<i>NCSX RFD</i> <i>Part I</i>	Number: RFD-12-017	RFD Description: Port Attachment Weld Deviation Request
Initiator: Doug McCorkle		Organization: Major Tool & Machine, Inc.
List of Impacted Documents: (<i>Specification, MIT/QA Plan, SOW, drawing, etc.</i>) NCSX-CSPEC-121-02-06; SE120-004;		
Cost Impact: (<i>If none, so state</i>): NONE		
Schedule Impact: (<i>If none, so state</i>): NONE		
Quality Impact: (<i>If none, so state</i>) : Quality improvement and improved welding distortion control.		
State Requirement Deviation is Requested For: (<i>Specification, MIT/QA Plan, SOW, drawing, etc.</i>): Ref: Drawing SE120-004, Sht 4, 5, 6, 7, 8, 9, 10, 11, 12, 13, 14, 15, 16, 17, 18, & 19. The drawing weld symbol for joining the port extension to the vessel.		
Full Description of the Deviation Requested: Background: NCR 19464 (attached) identified that MTM had used a different method for welding the port extensions to the vessel for VVSA segments #1 and #2. As indicated in the NCR, rather than following the design on the respective drawings, MTM elected to utilize and alternate methods by: <ul style="list-style-type: none">• Round ports - cutting the hole in the vessel to the o.d. size of t

Sketch of MTM Weld Concept

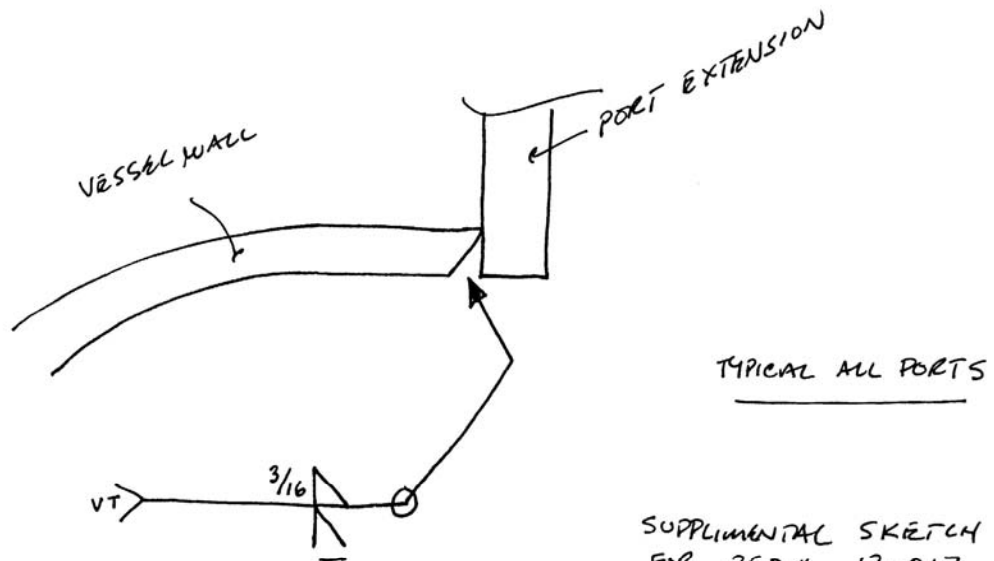
This sketch better defines the weld prep for the joint that attach the port stubs to the vessel wall on the first two units. The majority of the joint is filled in from the inside vessel surface, then we grind the outside (root side) until all irregularities are removed, and apply a fill pass and a cover pass (which creates the 3/16 fillet) on the exterior side.

All round ports: Current design requires the tube to be butted to the exterior surface of the vessel wall, prepped to the outside of the tube, and welded 100% with no backing weld or interior weld, with a continuous fillet around the exterior. The following was actually done: The hole was cut to the o.d. size of the tube and welding full penetration from the vessel interior (ground flush) with a continuous fillet weld around the tube exterior. The majority of the joint is filled from the interior, and the exterior is back ground and filled in for 100% penetration. A 3/16" continuous fillet is applied to the exterior of the joint for strength and to properly blend the two surfaces together.

RLM Signature: _____		
<p>Project Disposition:</p> <p><input checked="" type="checkbox"/> Approved. No ECP required. ECN will be prepared to note this NCR on the impacted drawings.</p> <p style="text-align: center;">_____ NCSX Systems Engineering Support Manager</p> <p><input type="checkbox"/> Approved. ECP - assigned and processed.</p> <p><input type="checkbox"/> Not Approved. Reason(s) for disapproval:</p>
